STAFF REPORT: MARCH 8, 2023 MEETING

APPLICATION NUMBER: 23-8237

ADDRESS: 2905 GARLAND (AKA THE OSSIAN SWEET HOUSE)

SCOPE: REPLACE REAR SECOND STORY PORCH* (WORK STARTED WITHOUT APPROVAL), INSTALL GLASS BLOCK WINDOWS

Witness: Detroit Police Inspector Norton Schuknecht, starting on page 33.

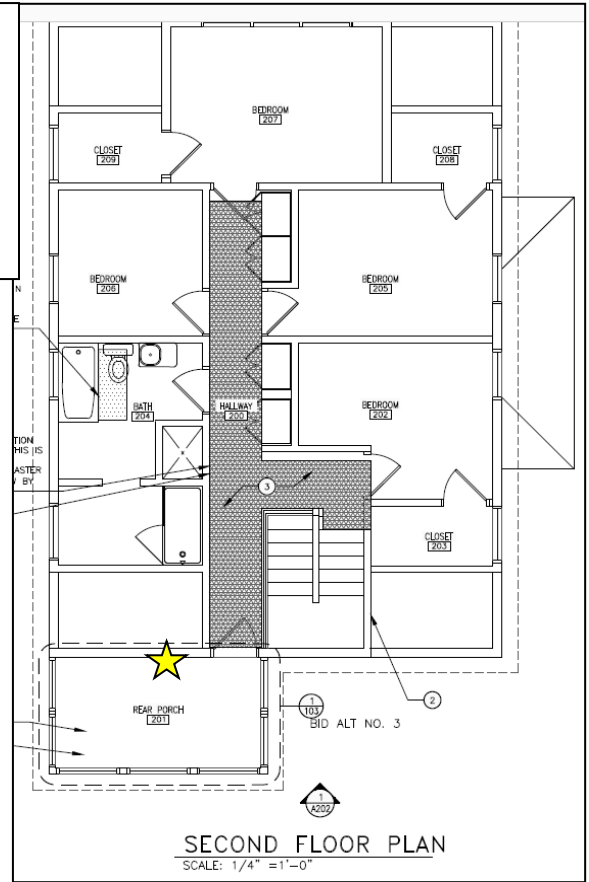
- Prosecutor Toms: *Did you go out onto the porch at the end of the upstairs hall?*
- Inspector Schuknecht: *Yes.*
- Prosecutor Toms: *That is the uncovered porch, is it?*
- Inspector Schuknecht: *It is.*
- Prosecutor Toms: *No roof on it?*
- Inspector Schuknecht: *No.*
- Prosecutor Toms: *There are two white posts at the outer corners of the porch?*

- Inspector Schuknecht: *Yes, one on each corner.*
- Prosecutor Toms: *And you got onto that porch through a doorway at the end of the second floor hall?*
- Inspector Schuknecht: *Yes, sir.*

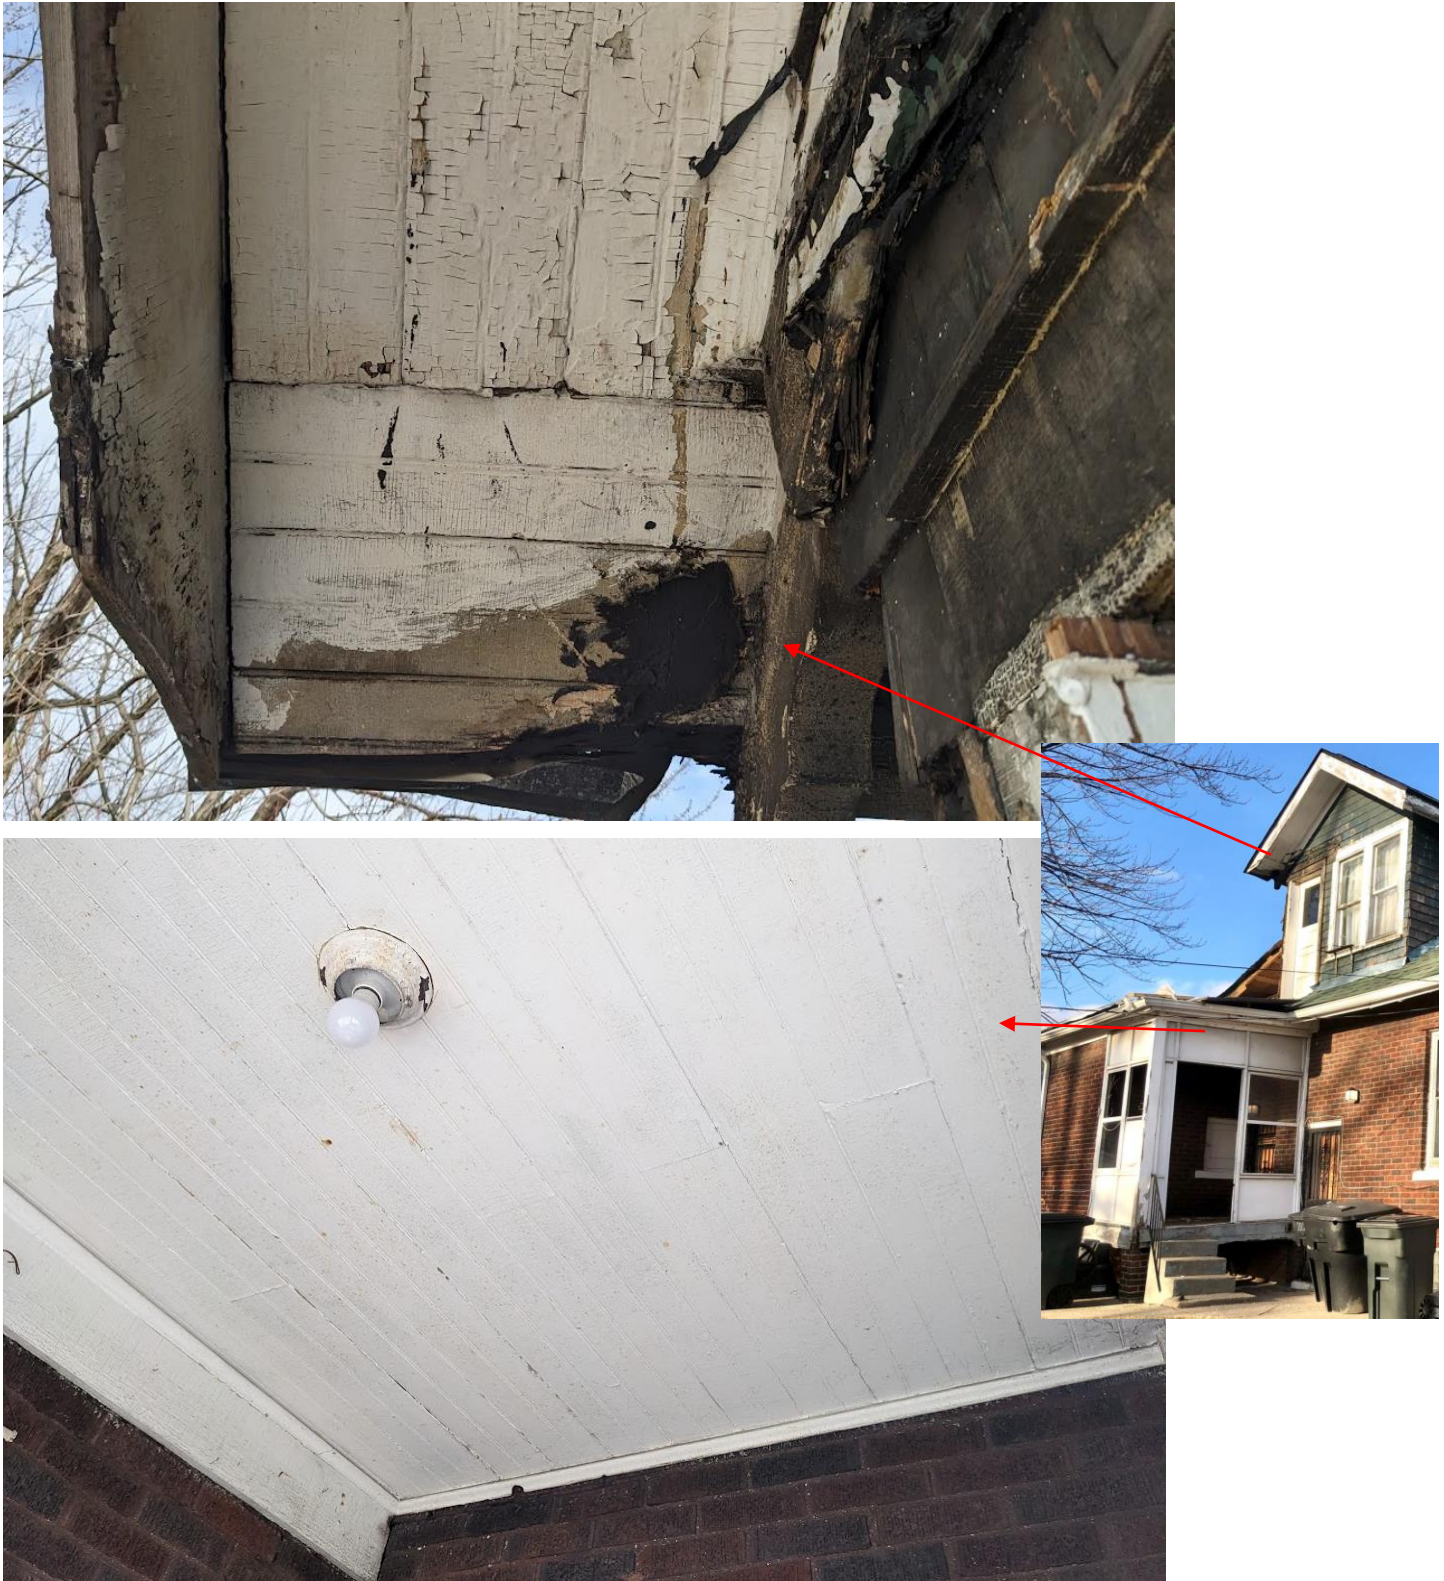
The electrical box installed on the outer wall confirms that electricity was not originally supplied to the porch; this box was likely added when the upper walls and windows were constructed.

Staff can't tell from the photos if the vertical members are continuous posts, or if the upper 4 x 4 lumber was attached when the porch was enclosed. The additional framing at the corner post and possible cut line at the interior post may suggest the latter.
